CAPTIVE POWER PLANT (CPP) PACKAGE
VISAKH REFINERY MODERNIZATION PROJECT (VRMP)
JOB NO. B016

TITLE	CARD CODE	REV.
SINGLE LINE DIAGRAM OF 33kv GIS SWITCHGEAR	BHEL DRG NO. PY-DL-1-M104-8801-01 CUST DRG NO. 03	
	SHT. No 01 NO. OF SHT. 01

COMMENT SHEET

PROJECT: VRMP PROJECT, VIZAG
NAME OF PACKAGE: CPP PACKAGE

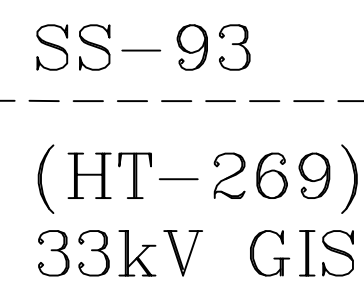
1.1	33kV Cable to SWGR-270 shall be 2 runs of 1CX630 sqmm copper / ph.	Noted and incorporated in the revised SLD.
1.2	BHEL has not provided Provide resolutions to HPCL comments sent vide email dtd 19/04/18. Pending points are reproduced below for ready reference: i. As per EDB, All master trip relay (86) shall be part of numerical relay. No electromechanical type relay shall be provided. ii. As per the contract - Section –C sub section C -2.3 interface between owner and EPCC contractor “Supply, installation, termination and jointing of 33kV cables from 33kV GIS to straight through joint location in existing 33kV cables to switchgear 71-HV-111 including straight through jointing kit. This includes cutting of existing 33kV cables from existing HT-269 to 71-HV-111 at suitable location within CPP and jointing to new 33kV cable from 33kV GIS using straight through joints..” Same to be included in Notes.	Noted and incorporated in the revised SLD.

Client comments	
1.3	The physical location of Relays 87T, 64LV (of 220/66KV Tr & 220/33KV Tr) will be on 220KV GIS end. Hence, burden of 66KV GIS/33KV GIS CTs (which are being used as 2nd input to 87T, 64LV at 220KV GIS side) to be checked / provided by BHEL.	Noted and incorporated in the revised SLD, Please note that, as the relays of 87T,64R(LV) are in 220kV GIS relay panel. The Knee point voltage (V_k), Magnetizing current (I_m) & R_{ct} values of CTs (located in 33kV/66kV GIS giving 2 nd input to 87T,64R(LV) relays) shall be informed by the 220kV GIS vendor based on the relay model selected at their end. Accordingly requirements will be informed to 33kV /66kV GIS vendors

1.4	BHEL to confirm the CT ratios of 66KV GIS/33KV GIS CTs(which are being used as 2nd input to 87T, 64LV at 220KV GIS side) to enable PTC to ensure matching factors for P643 relay.
